Re: SSD 7931 Metz Solar Project – Final Layout

Accordingly, please refer to attached updated proposed final layout of the development attached at Appendix A (document ref: *METZSF-CIV-DWG-101 - Site Equipment Layout Rev2*).

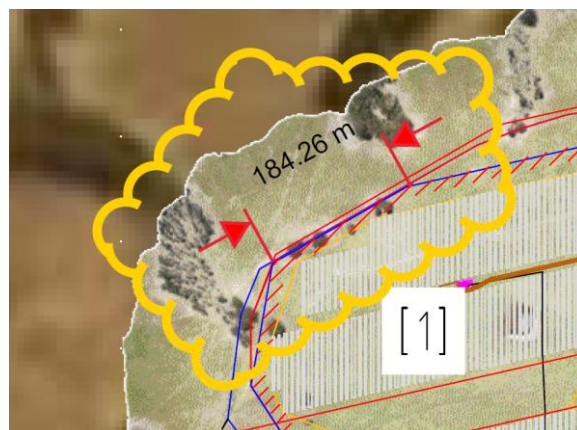
We would like to point to a change in the Final layout. The Asset Protection Zone has been reduced to minimum 10m from a previous 15m. To clarify, a 15m Asset Protection Zone will be maintained all round the site and will only be reduced to 10m in a 185m section on the north-western corner of the development (shown in a revision cloud in the document ref: *METZSF-CIV-DWG-101 - Site Equipment Layout Rev2 – Sketch* and pasted here below.)

In this section, the fence would be moved inwards towards the Solar Farm's equipment and away from the property boundary fence. So, from the solar farm equipment outwards, we would have, a 10m Asset Protection Zone, the fence, a 5m wide path and then the boundary fence (existing).

This path comes at the request of the landowner, for farming operations and access over the land. The landowner keeps operational control over land not leased to the solar farm (that envelops the solar farm). In this particular area, the solar farm extends to the limit of his property, cutting access to either side of the farm. A 5m wide path would allow him to continue his operation unencumbered.

There will be no impact to the Development Consent.

- No changes to the location of any equipment are proposed.
- No other impacts are expected.

This 10-meter Asset Protection Zone would still be in line with the Construction Bushfire Management Plan approved by RFS. (Document ref: 05.05.05.07.09 METZ_BFMP_001B section 4.1.2 ASSET PROTECTION ZONE)
